ADDENDUM NO. 2

EASTERN SHORE REGIONAL LIBRARY

IFB No.: 716

Date: April 22, 2019

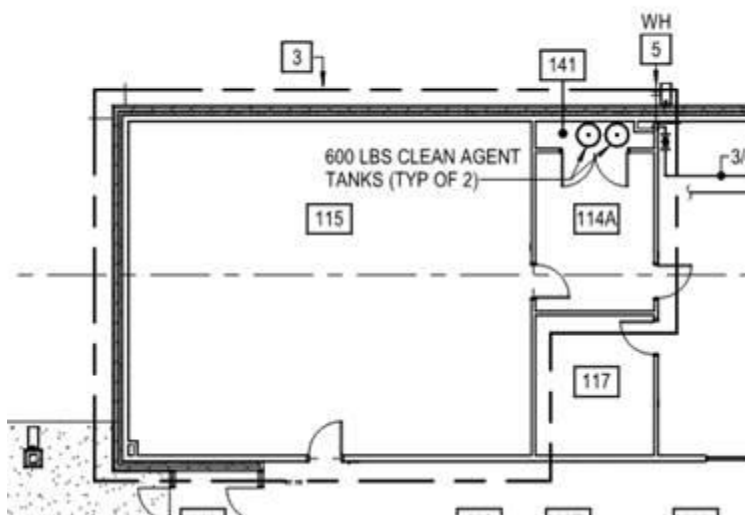
5. Question: The prints are not clear on what the preaction system will have to protect. Can we get that clarified?

Response: Contractor to refer to Sheet P202 Note 3 and the callout box on plan. The document indicates Rooms 141, 115 and 114A to be applicable.

3 THIS AREA SHALL BE PROTECTED WITH A CLEAN AGENT FIRE SUPPRESSION SYSTEM. EXTEND PREACTION SPRINKLER SYSTEM TO PROVIDE COVERAGE FOR THIS AREA. SEE DETAIL, SHEET P005, FOR FURTHER INFORMATION.
